SUBJECT: Hydraulic Analysis of the Proposed Zinfandel Estate Subdivision

Appendix B – Response to June 9, 2021 comments received from River Focus Water Resources Consultants.

Figure 13: Change in 2-, 10- and 100-yr water depths and inundation extents for Alternative 2 relative to existing conditions.

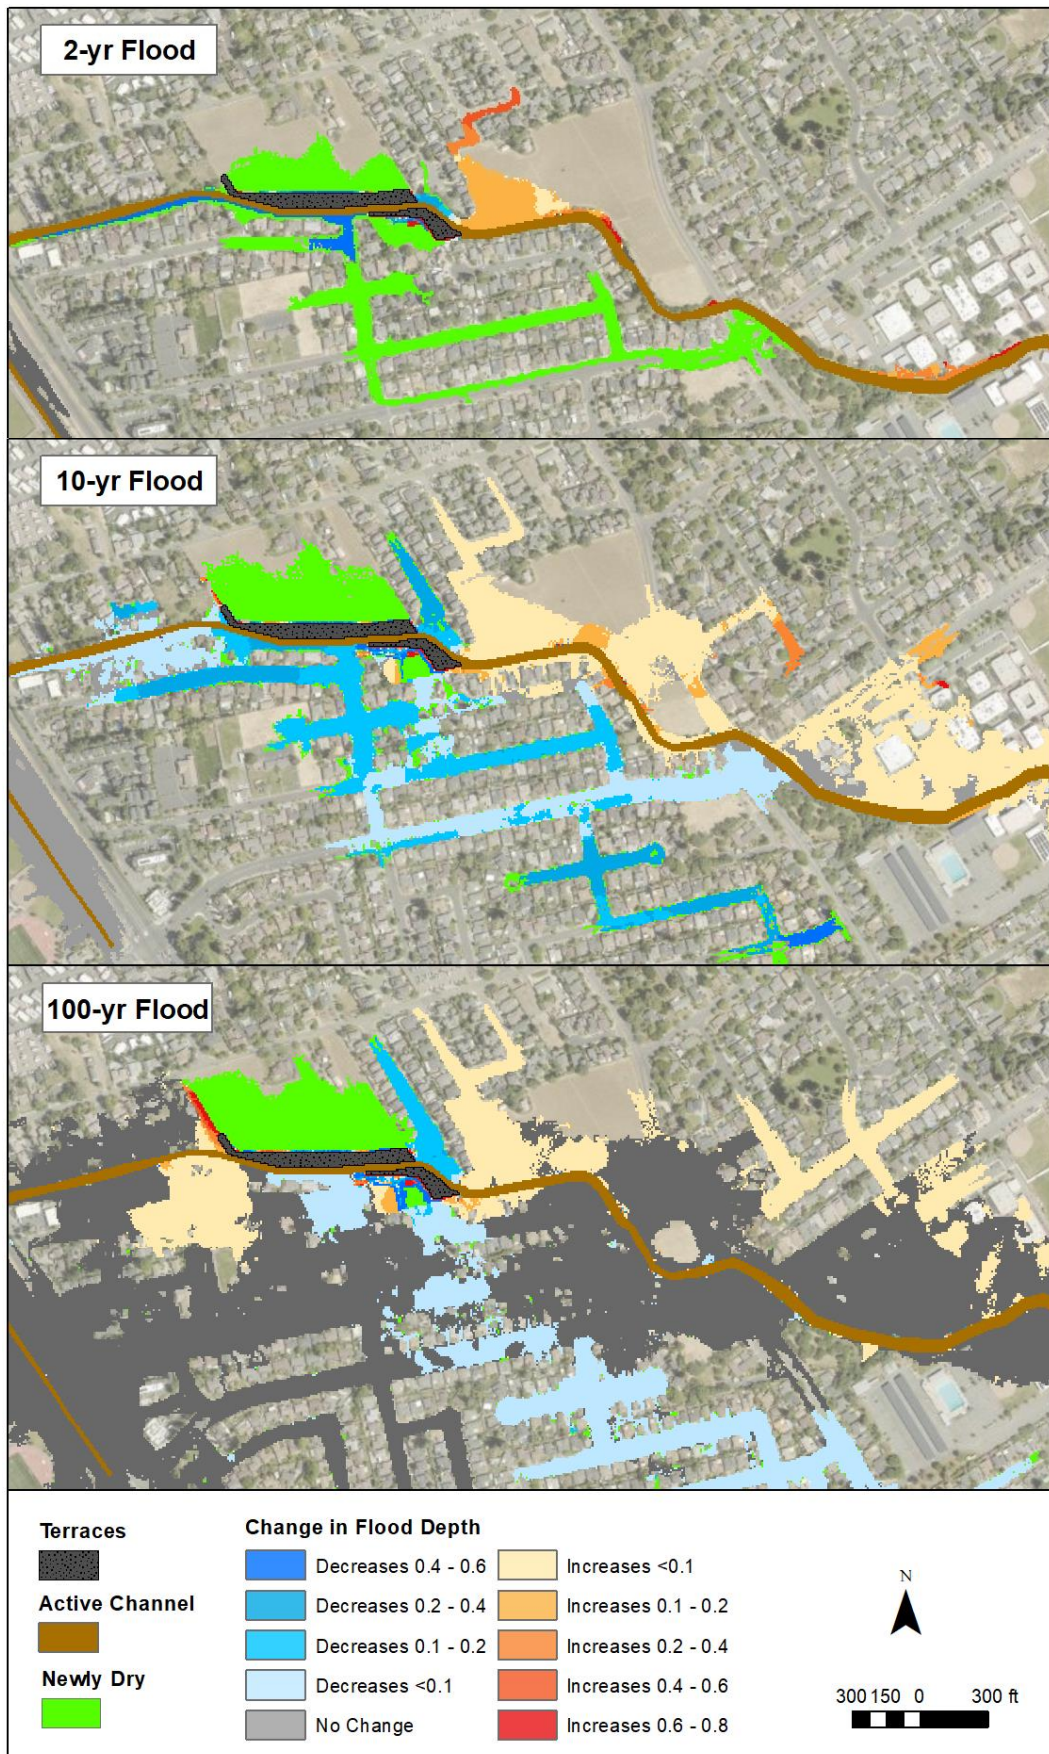
5. Figure 23 of the Hydraulic Analysis tech memo shows the maximum change in WSE for each of the alternatives for each modeled flood event. Please confirm the maximum change values. For example, for preferred Alternative 2 the 100-year max change is shown as 0.1 ft; however, the WSE difference plot (Figure 1 above) shows a max change of 0.2 to 0.4 ft.

The maximum WSE change values reported in Figure 23 of the prior report represent changes within the channel of Salvador Creek as simulated at cross sections within the 1-dimensional component of the model, whereas the changes shown in the WSE difference plots represent changes in inundation on the floodplains as simulated with the 2-dimensional component of the model. In the current report, the maximum changes in the channel and on the floodplain for Alternative 2 are shown in Table 2 and Figure 13 respectively.

Figure A1: Detailed mapping of existing and proposed WSEs in the vicinity of the house located on the neighboring parcel west of the proposed project on the north side of Salvador Creek.

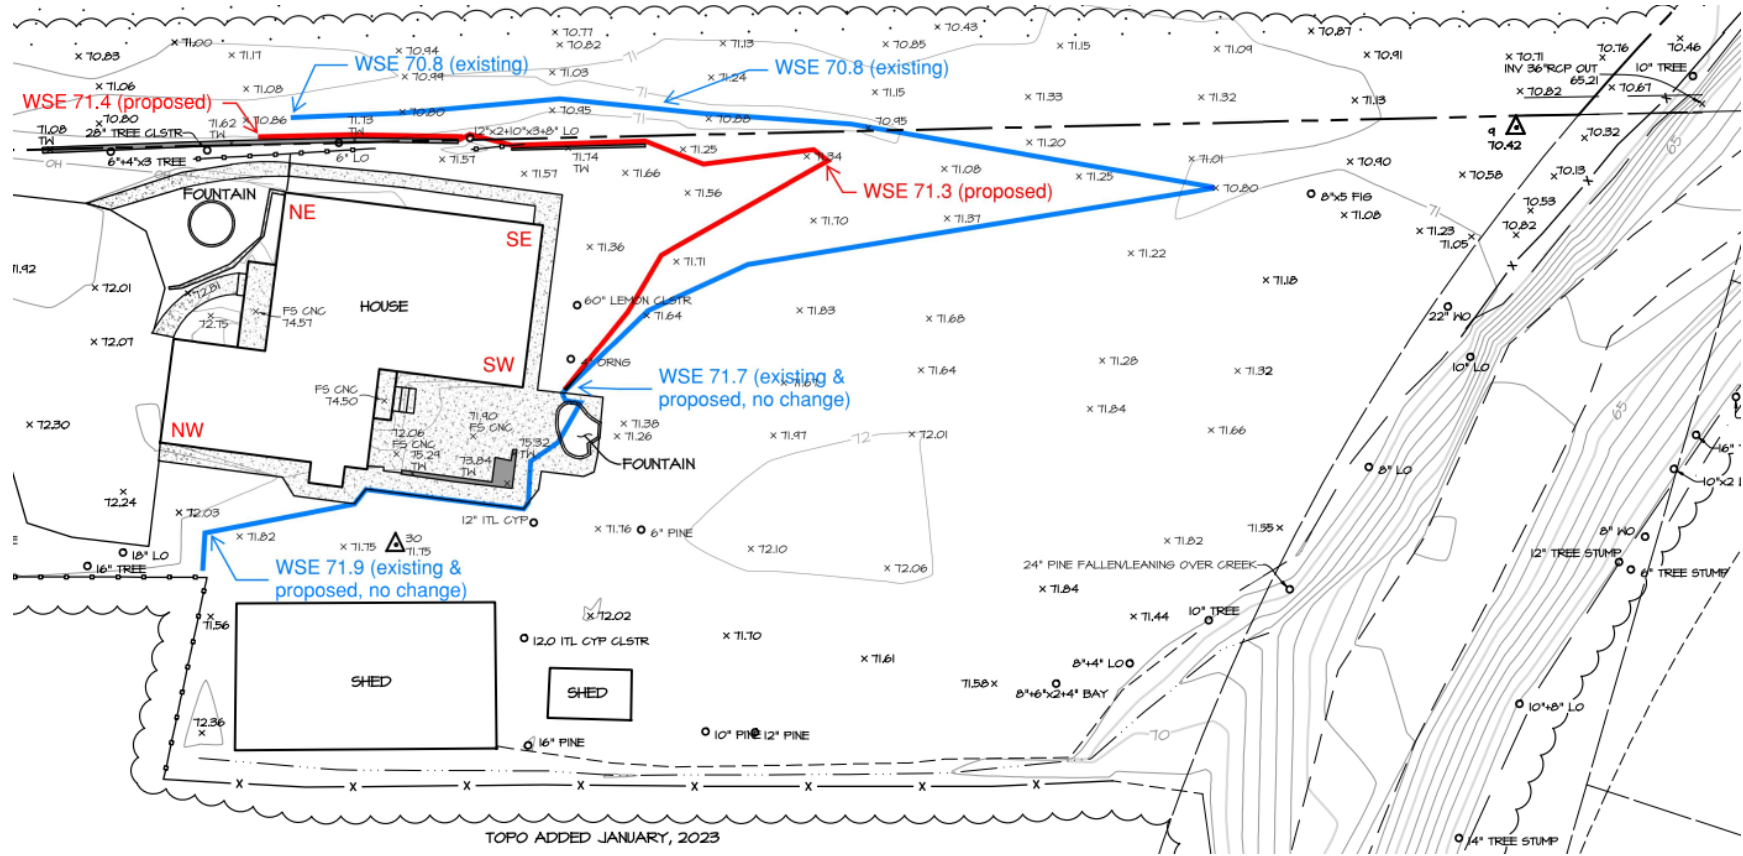
1. The preferred Alternative 2 causes a 0.2 to 0.4 ft increase in computed 100-year flood elevations on the north (left overbank) floodplain, immediately upstream of the project, as well as on the south (right overbank) floodplain (see Figure 1). These increases appear to be the result of floodplain flows being blocked by the proposed fill (Figure 2). On the north side, the proposed floodplain terracing tapers off at the upstream end of the project to the point where there is no connection between the upstream floodplain flow and the proposed terracing during the 100-year event.

To reduce the increase in flood elevations, some of the floodplain conveyance may have to be preserved (for example, see Figure 3). Alternatively, floodplain relief culverts through the fill, and discharging to the terracing, might be an option. Note: All figures in this review document were taken from the *Hydraulic Analysis* tech memo with annotated comments, labels, and arrows added by River Focus.

Several changes to the Alternative 2 design were made to mitigate the effects of floodplain blockage at the upstream extents of the project area on the north and south banks. On the north bank, the terrace was widened at its upstream end as suggested by River Focus. Additionally, the fill prism was set back 15-ft from the property line such that increases in inundation associated with floodplain flows interacting with the fill will largely be contained on the project parcel. We also investigated using relief culverts to mitigate the north bank increases, however this strategy was not as effective as the adopted terrace changes. On the south bank, the extent of the fill prism was reduced by eliminating the western-most lot and instead lowering the grades in this area. The proposed driveway parallel to the channel was also lowered. The changes on the north side resulted in a decreased area where inundation depth increases extend onto the neighboring parcel to the west. Additional topographic survey was collected surrounding the neighbor's house and the existing and proposed 100-yr WSEs were mapped at a finer scale than is possible using the hydraulic model alone. This exercise reveals that although Alternative 2 does result in the WSE in this area increasing from 70.9-71.9 to 71.3-71.9, neither the exiting nor proposed WSEs are high enough to result in inundation that extends to the edges of the house (Figure A1). The changes on the south side resulted in all increases in inundation depth in excess of 0.1 ft being contained on the project parcels thus fully mitigating against significant off-site impacts.

Figure A2: Surveyed elevations in the vicinity of the houses located downstream of the proposed project on the south side of Salvador Creek (the existing and proposed 100-yr water surface elevations in this reach are 68.1 and 68.2 ft respectively).

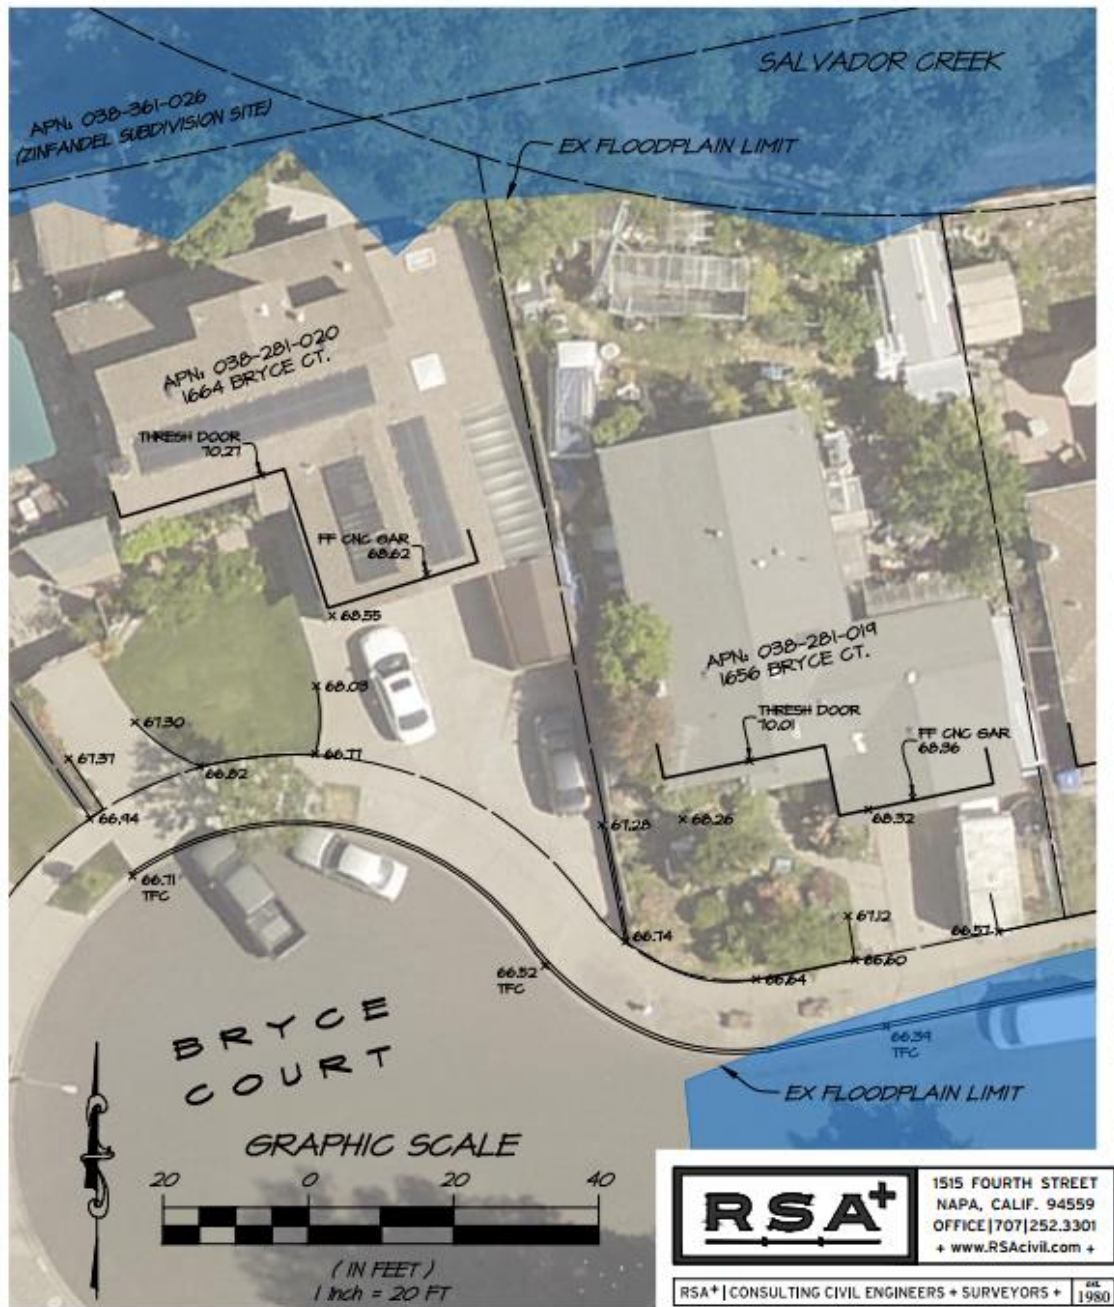
3. For Alternatives 2 and 3, it is difficult to determine whether the floodplain benefits outweigh the areas where flood depths are increasing. This is because not all increases (and decreases) are alike. For example, flood depth increases on undeveloped land may be more acceptable than increases affecting existing structures. For each recurrence interval event, please provide a comparison of:
 - a) The number of insurable structures and the total floodplain area with WSE increases greater than 0.1 ft; and
 - b) The number of insurable structures and the total floodplain area with WSE decreases less than 0.1 ft.

The table below provides the requested information for Alternative 2. As discussed above in the response to item #2, Alternative 3 has been removed from consideration due to unacceptable impacts. Changes in floodplain inundation on the proposed project parcels were excluded from the tabulation of floodplain area change to avoid skewing the results. The proposed condition results in reductions in offsite floodplain inundation area for all three flood events. The number of structures with decreases in WSE is greater than the number of structures with increases for all three flood events. The raw model outputs do indicate increases in 100-yr WSEs greater than 0.1 ft in the vicinity of two houses, however additional surveying and more detailed floodplain mapping was performed in the vicinity of the houses which revealed that the finished floor elevations are above both the existing and proposed 100-yr WSEs, therefore these structures were excluded from the table. The detailed mapping for the house upstream of the project on the north bank is discussed above under Item #1 and presented in Figure A1, and the detailed mapping for the other house downstream of the project on the south bank is presented in Figure A2. These statistics clearly show that the project results in a net reduction in flood risk to the surrounding neighborhoods.

Figure A3: Comparison of existing and proposed velocities (top) and shear stresses (bottom) for the 10-yr flood.

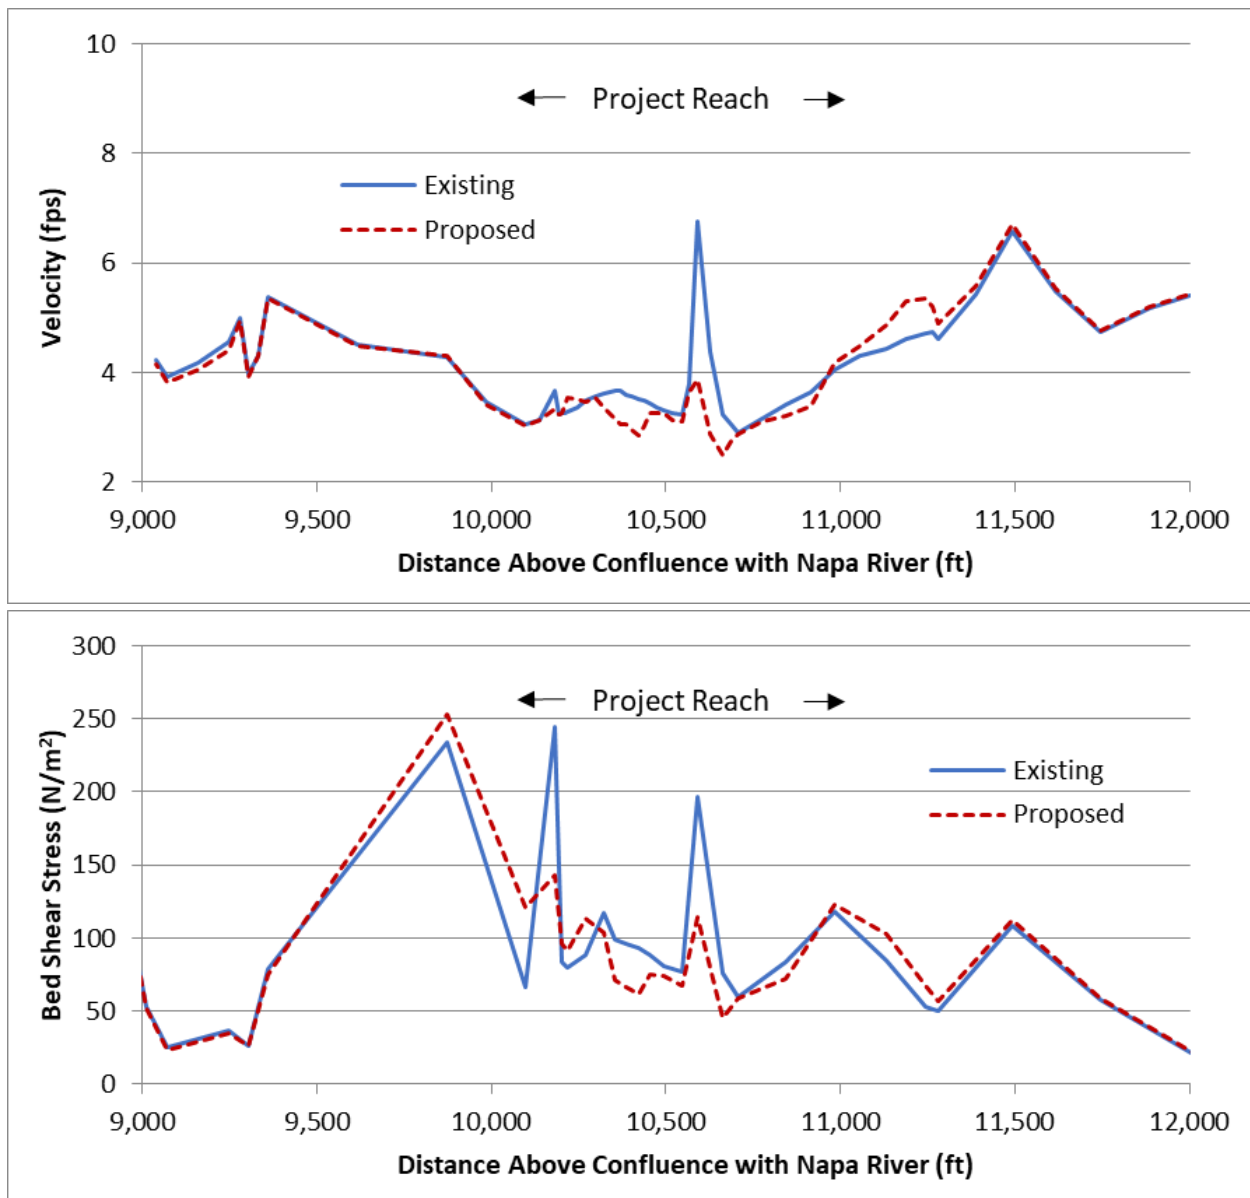
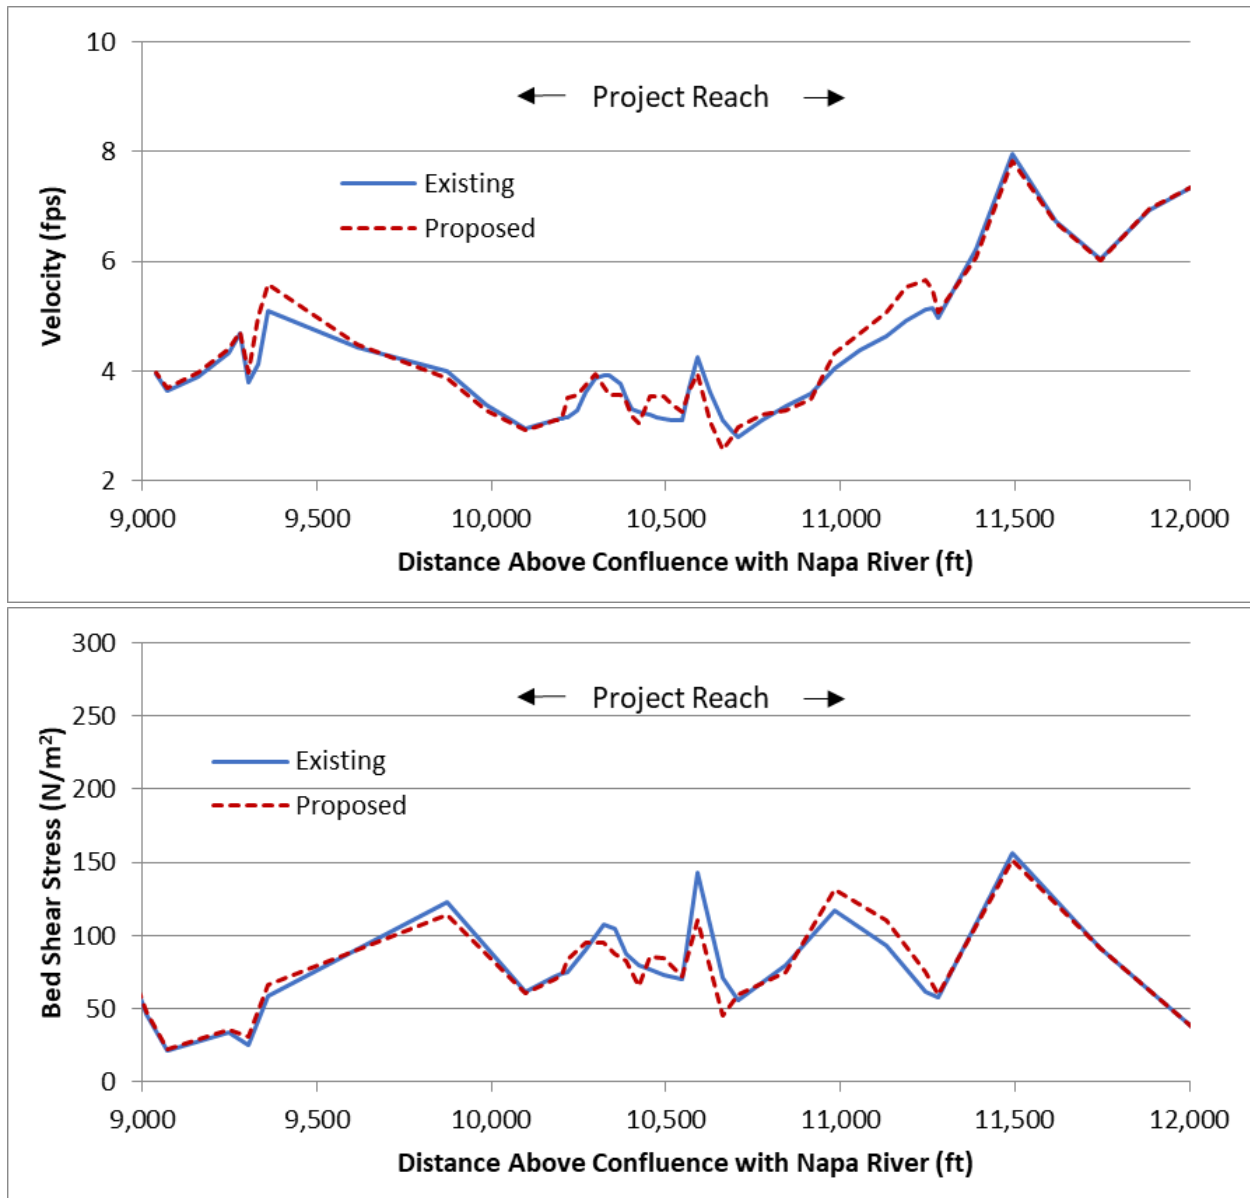
7. The preferred Alternative 2 has additional flow in the main channel downstream of the project, which could have an impact on stream stability. Please provide a discussion—either in the hydraulic analysis or with the geomorphic analysis—of whether any increased velocity or shear stress will adversely impact stream stability given the existing bank vegetation and/or protection. Please include figures showing computed channel velocities and shear stresses for existing and proposed conditions, as well as difference plots. Note: For the velocity and shear stress figures, please do not cover the main/active channel with a brown polygon (as in the flood elevation plots).

As requested, simulated channel velocities and shear stresses for existing and proposed conditions are shown below in Figures A3 and A4. Note, that the channel is simulated using a 1-dimensional formulation which is why the flood elevation plots show the channel as a brown polygon. The polygon is not covering up information but rather is intended to delineate where

The velocity and shear stress comparisons reveal that the increased flow in the channel downstream of the project associated with Alternative 2 results in only very minor increases in these parameters. Matt O'Connor performed an additional reconnaissance survey of the creek between Lassen Avenue and Jefferson Avenue on June 1, 2023 to assess existing channel stability and potential vulnerability to erosion. This reconnaissance revealed that much of the right lower bank is armored by a vertical rock revetment about 3 ft or less in height that appears to have been placed in a stable stacked arrangement, probably at the time of construction of the channel. Portions of the left bank are armored by plates of concrete slab that appear to be waste material. These revetments appeared stable; no areas of undermining or failure of revetment were observed.

Given hydraulic simulations that indicate very little change in velocity and bed shear stress in Salvador Creek with the proposed project and the observed channel conditions, the proposed project does not pose a substantial risk of destabilizing this reach of Salvador Creek.
